Pentium® II Xeon™ Processor Specification Update

Release Date: November 1999

Order Number: 243776-017

D30. Thermal Sensor May Assert SMBALERT# Incorrectly

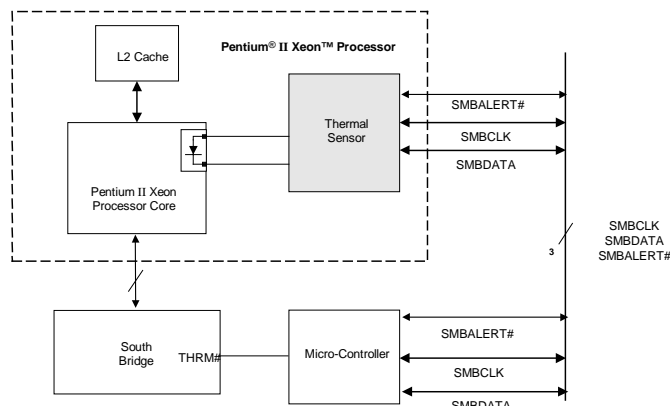
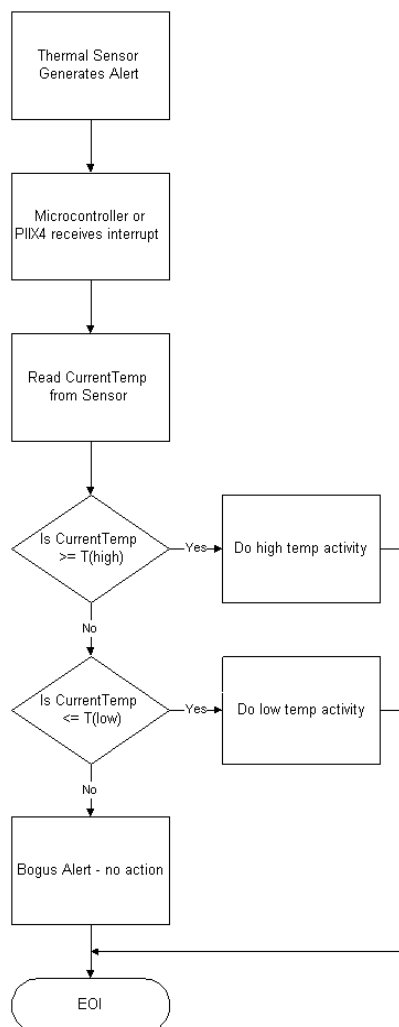
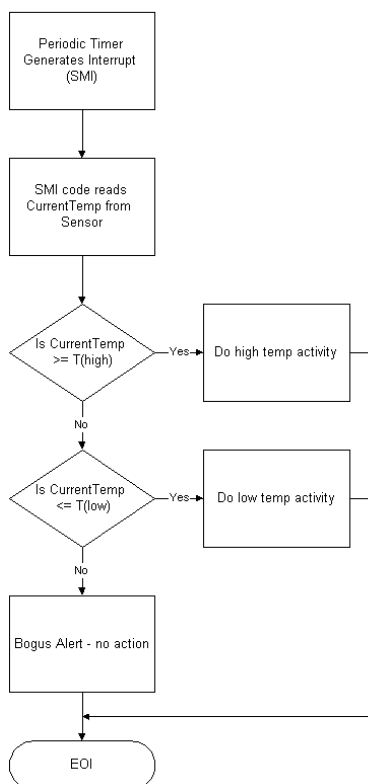
Problem: The Pentium II Xeon processor has a thermal sensor that monitors the processor core's temperature. The thermal sensor asserts SMBALERT# if the processor temperature exceeds the temperature limits set in the Alarm Threshold Registers (T_{HIGH} , T_{LOW}). It also sets the corresponding Status Register bits to identify the cause of the interrupt. Figure 1 gives one example of the how the SMBALERT# signal could be used in a system.

Under the conditions described below, the thermal sensor incorrectly generates the SMBALERT# interrupt. All of the following conditions must be met to trigger a false interrupt:

Workaround: Three different (mutually exclusive) workarounds are possible:

1. Before servicing an interrupt from the thermal sensor, read and compare the processor thermal reading with the threshold limits (T_{HIGH} or T_{LOW}). Figures 2 and 3 provide basic flowcharts for the implementation of this workaround in an interrupt driven system.
2. If the firmware implemented polls the Status Register only, then before taking any action, re-read the temperature register and do a comparison with the alarm threshold limits (T_{HIGH} or T_{LOW}) to determine if the value is actually still within the temperature window.
3. Use a temperature polling scheme to monitor the processor temperature
